## Product Change Notification

### Title: PCN #2024004 TDK-Lambda Americas Inc. PXC-M case tooling change

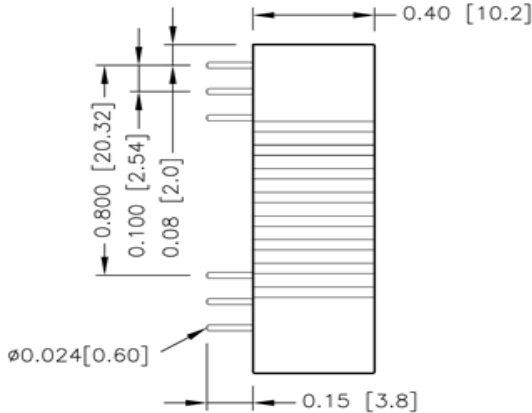
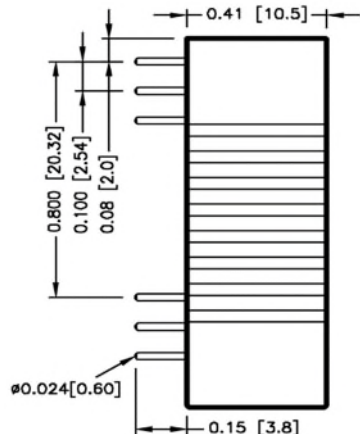
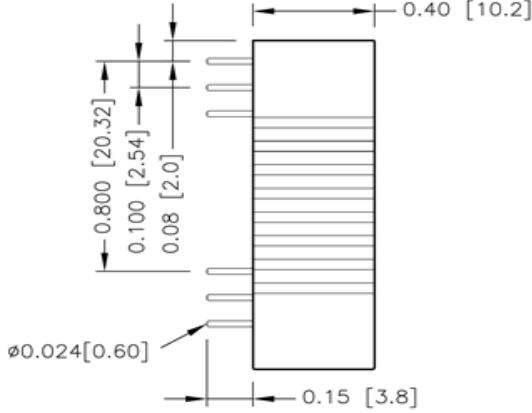
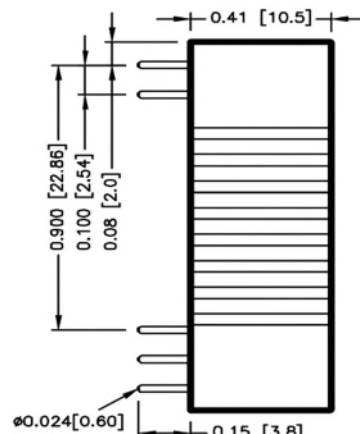
The case tooling for the PXC-M03, PXC-M06 and PXC-M10 series of DC-DC converters is being replaced to improve the manufacturing process. The slot previously used during the potting process is being removed, increasing the case height by 0.3mm. There are no changes to the overall product price or function. Safety certifications are not impacted.

| Change                | Before                                                                                                  | After                                                                                                    |
| Height Pinout Style B | <p>10.2mm±0.5mm</p>   | <p>10.5mm±0.5mm</p>   |
| Height Pinout Style A | <p>10.2mm±0.5mm</p>  | <p>10.5mm±0.5mm</p>  |
